| Range SA Large Regional | Model W100 | N° T.I. 01_2025 |
| Serial Number 52420750 | Subject Added TWO RUBBER PADS on the LOWER DOOR COVER | |

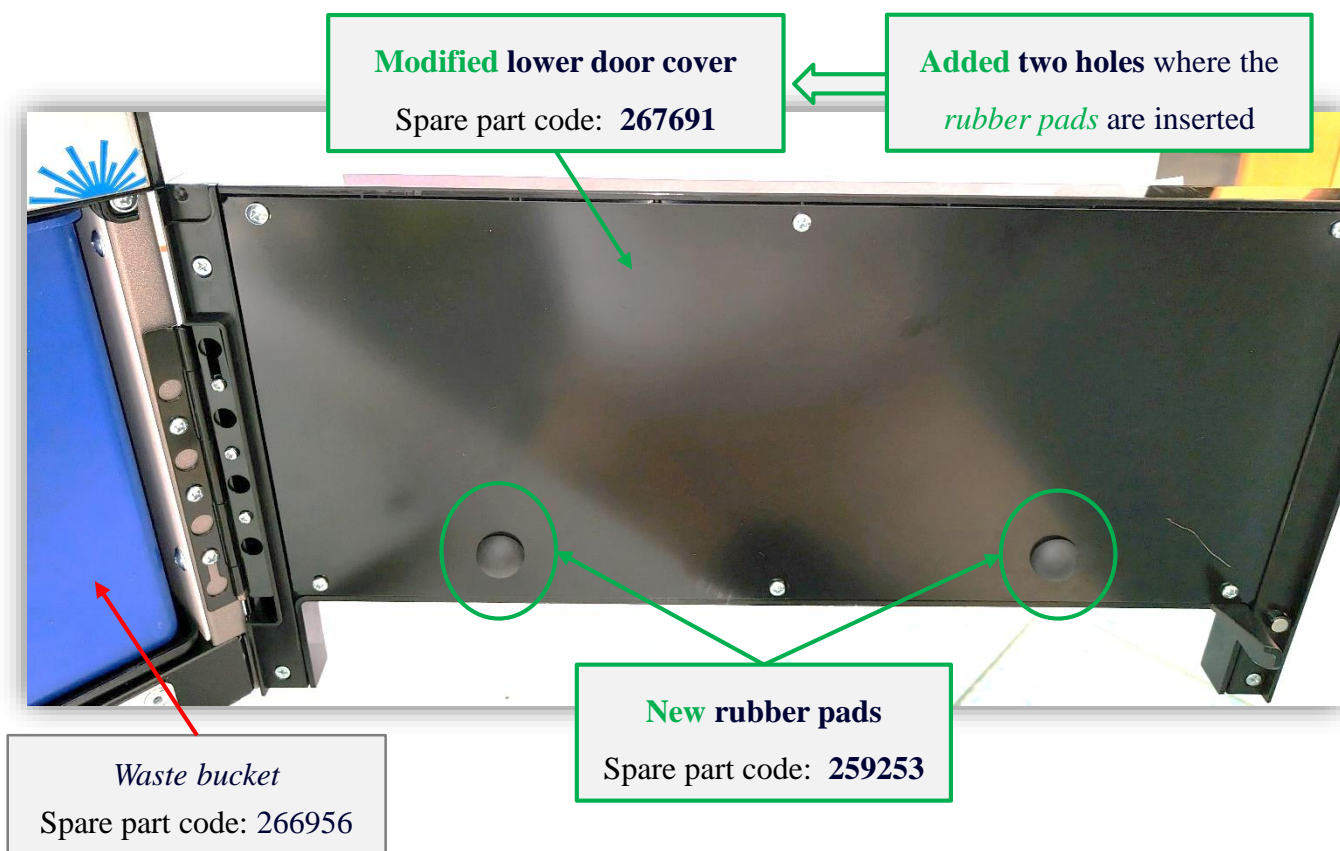
Be informed that with the aim to guarantee the proper position of the *waste bucket* (spare code: **266956**)

Two rubber pads have been added on the *lower door cover*

✓ Machines concerned by modification from S/N **52420750**.

For machines previous to above S/N it is possible introduce the **new solution**, by ordering:

1. **N. 2 rubber pads** - spare code: **259253**
2. **N. 1 modified lower door cover** - spare code: **267691**
